EXPANSION & RENOVATE AS NEW – PHASE 1

**CRYSTAL LAKE ELEMENTARY SCHOOL  
284 SANDY BEACH ROAD  
ELLINGTON, CT 06029  
STATE PROJECT NO. 048-0058 EA/RR/PS**

**DATE: December 31, 2013**

The following changes to the Drawings and Project Specifications shall become a part of the Drawings and Project Specifications; superseding previously issued Drawings and Project Specifications to the extent modified by Addendum No. 3.

Drawing Number:  
SKA1  
Bid Phase

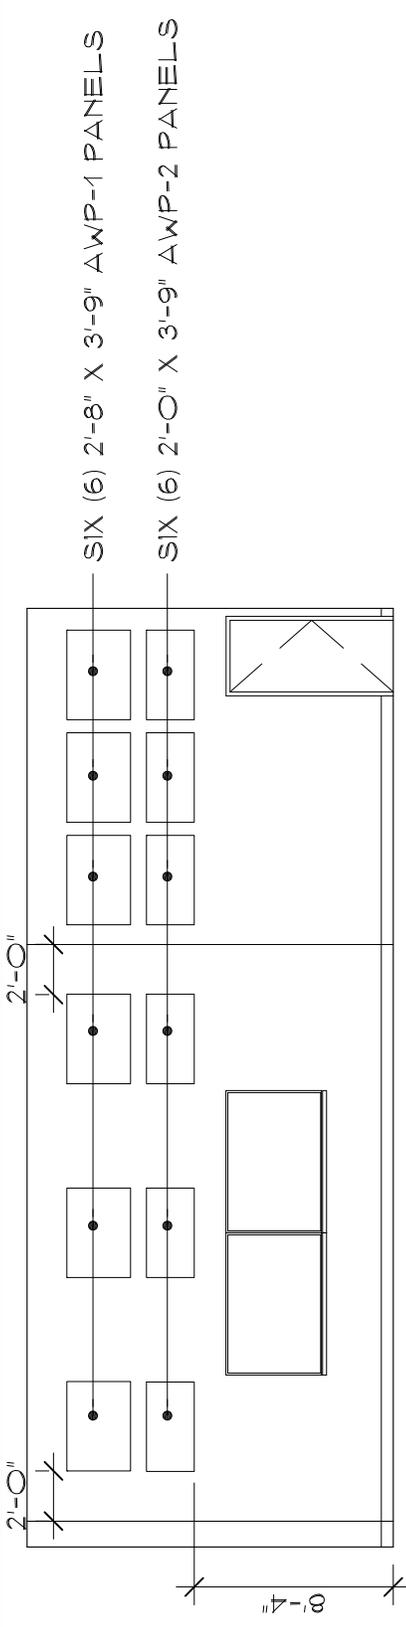
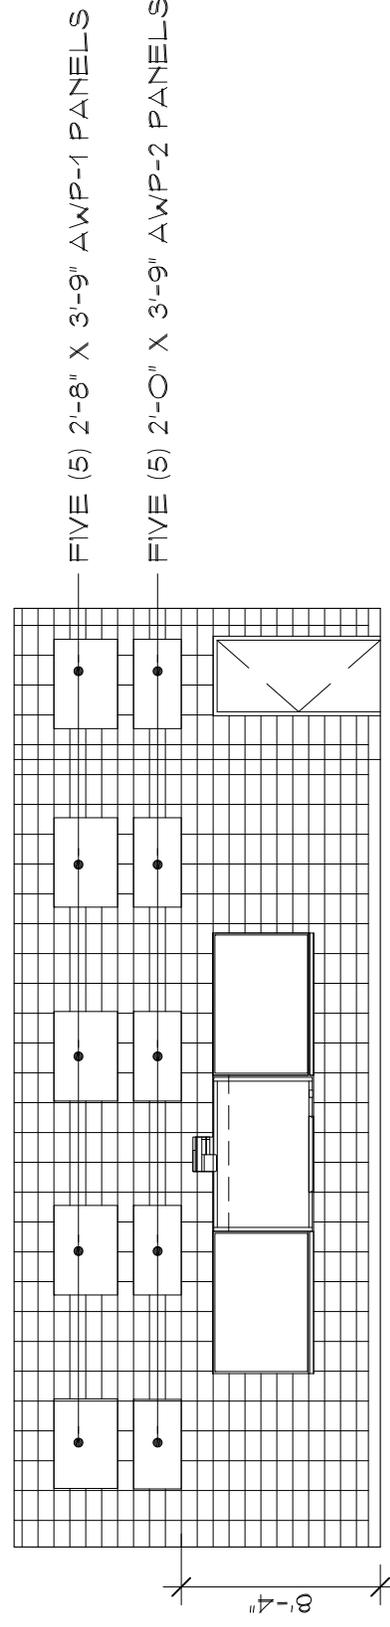
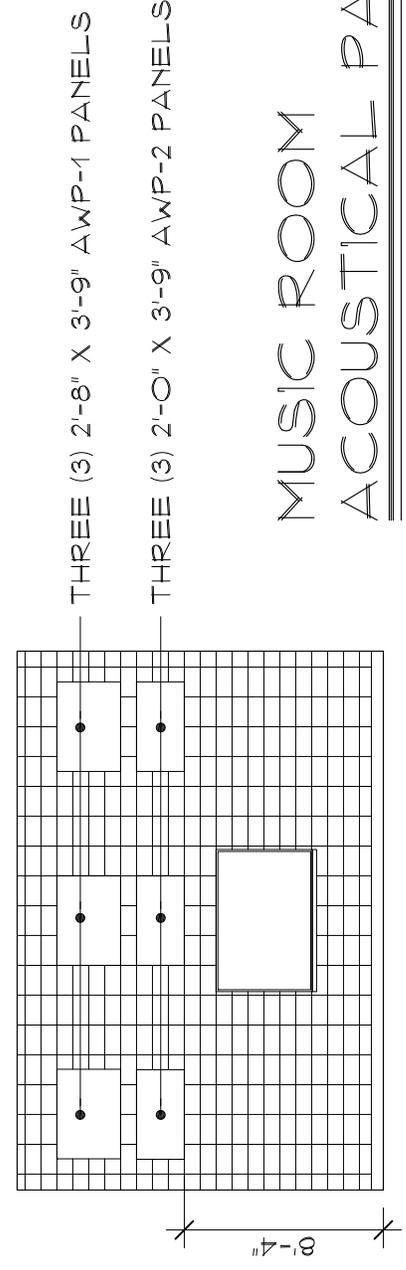
- DRAWING SK A1, Music Room Panels.
- DRAWING SK A2, Aluminum Curtain Wall Frames.
